Re: File No. PLN20-0105  
Design Review and Grading Approval  
3085 Paseo Vista

The following is a response to comments dated June 14, 2021:

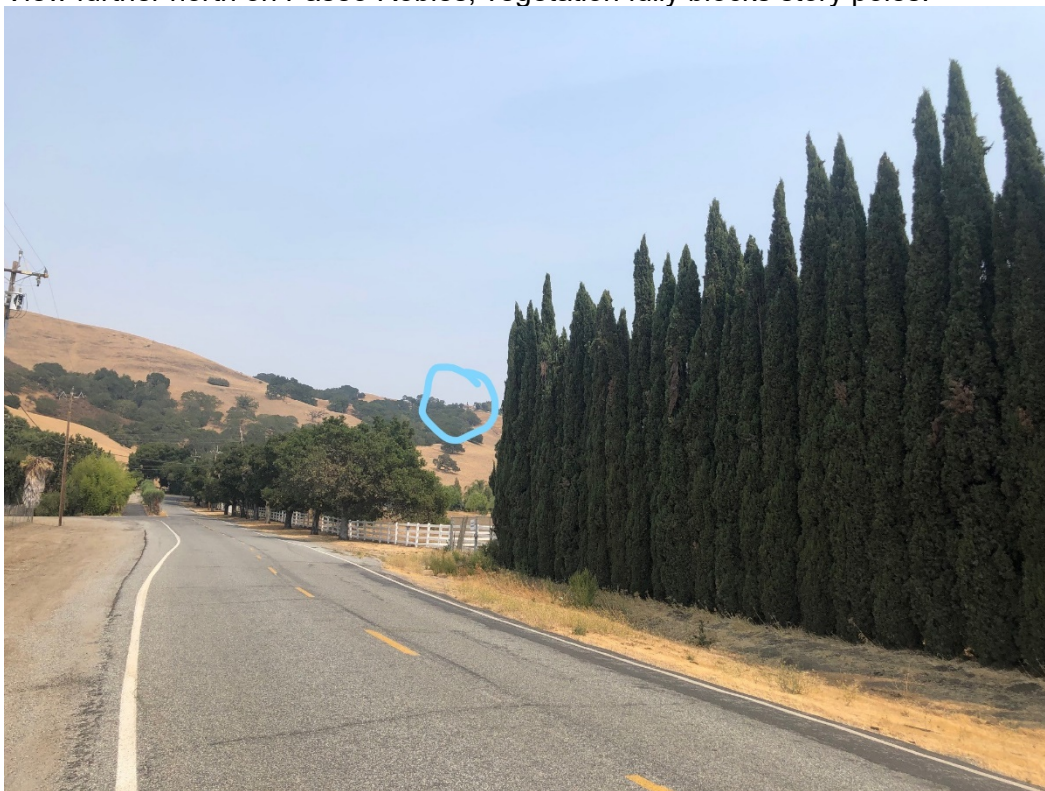
1. Added note to remove debris and hydroseed
2. Submitted revised color board
3. Pictures of story poles of the proposed residential accessory structure submitted below

View from Paseo Robles. Story poles are blocked by house and tree to the left of the house. This is the most visible location of the story poles.
